BOONE COUNTY, MISSOURI

Request for Bid #: 35-18JUL19 – Construction of Boone County Support Services Building

ADDENDUM #4 - Issued July 16, 2019

SHEET A4-3

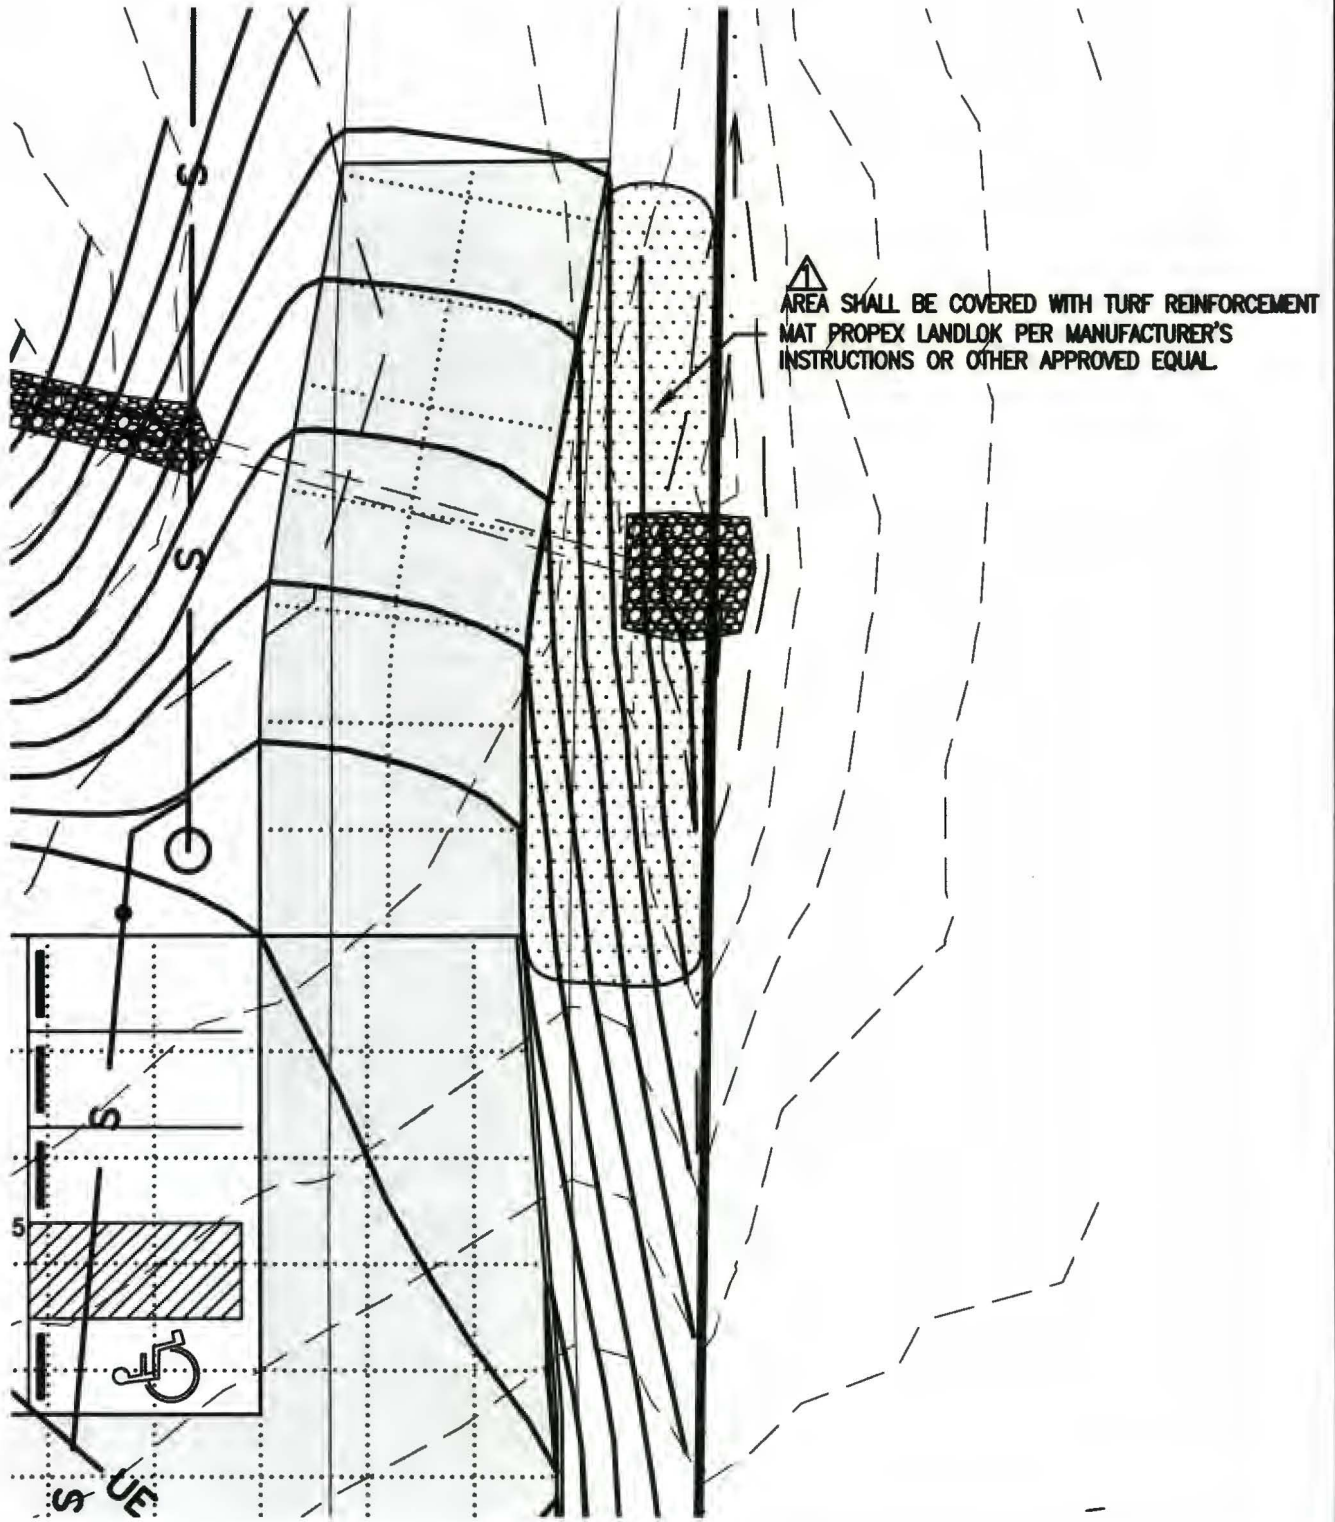
1. Grading and Erosion Control to modify existing dam and spillway as shown on attached sheet A4-1.
2. Installation of Turf Reinforcement Mat (Propex Landlok or equivalent) at the location shown on sheet A4-2.
3. Modification of the existing Pond Outlet Structure Orifice per the detail on sheet A4-3.
4. The Site Concrete Joint Locations as approved by Resource Management are shown on sheet A4-
